No booting issue_J4 contact issue

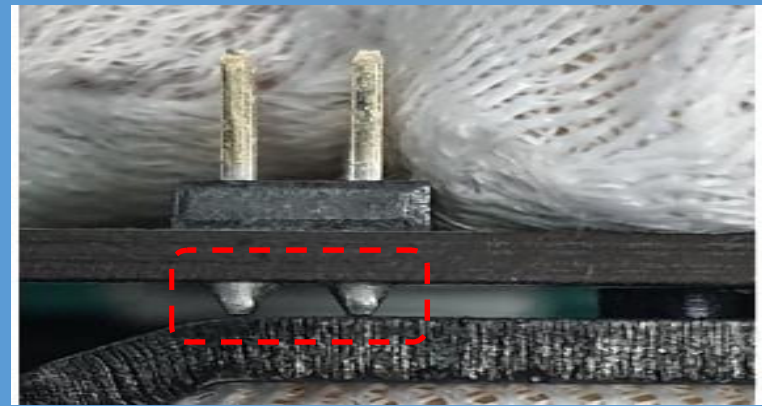
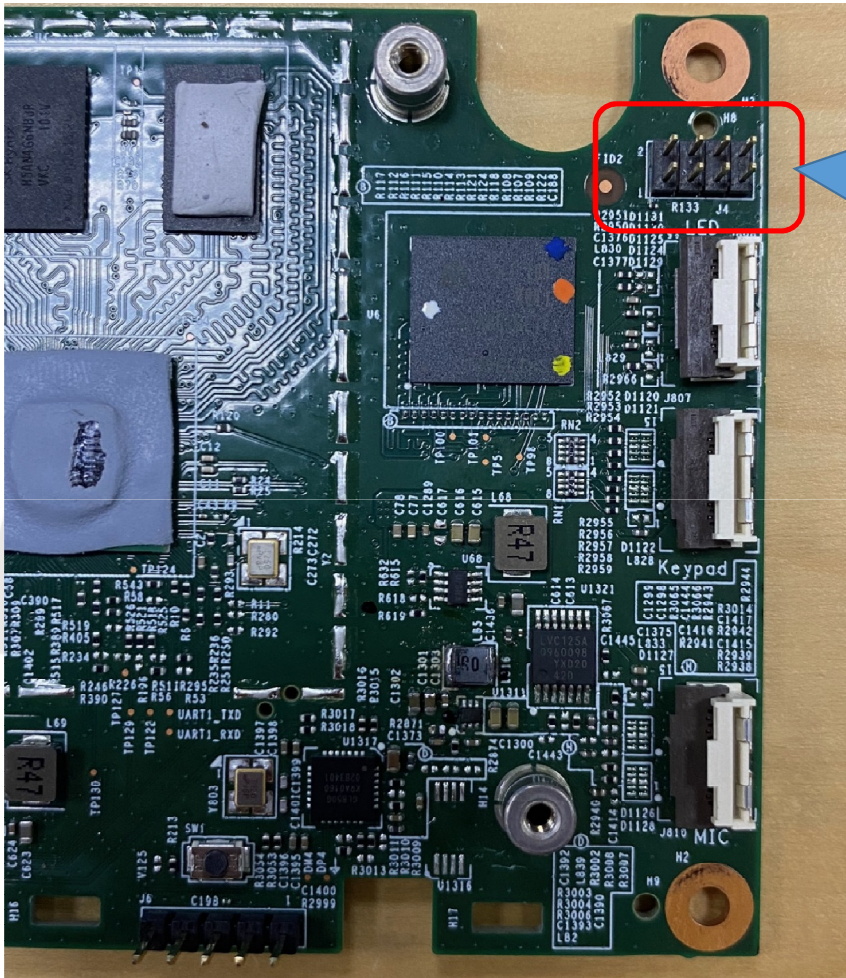
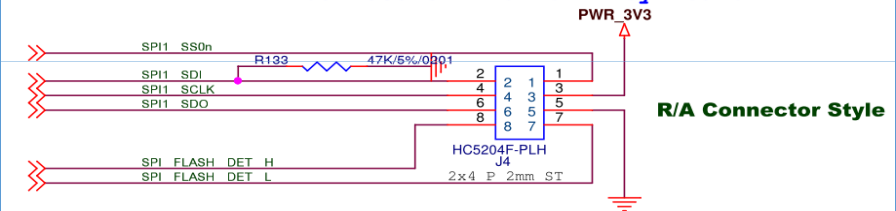
1. The J4 is used for debug port of VS550
2. The J4 pin header is very close to the bottom heat spreader of main board. If J4 is in contact with the heat spreader, the main board may not bootup properly because the 3.3V power short-circuited to ground
3. The leg of pin header changed to normal type in DVT3 build in order to solve the soldering issue on ground pin of pin header. And we will change the pin header to short leg type in MP to prevent the risk of short issue after assembly.
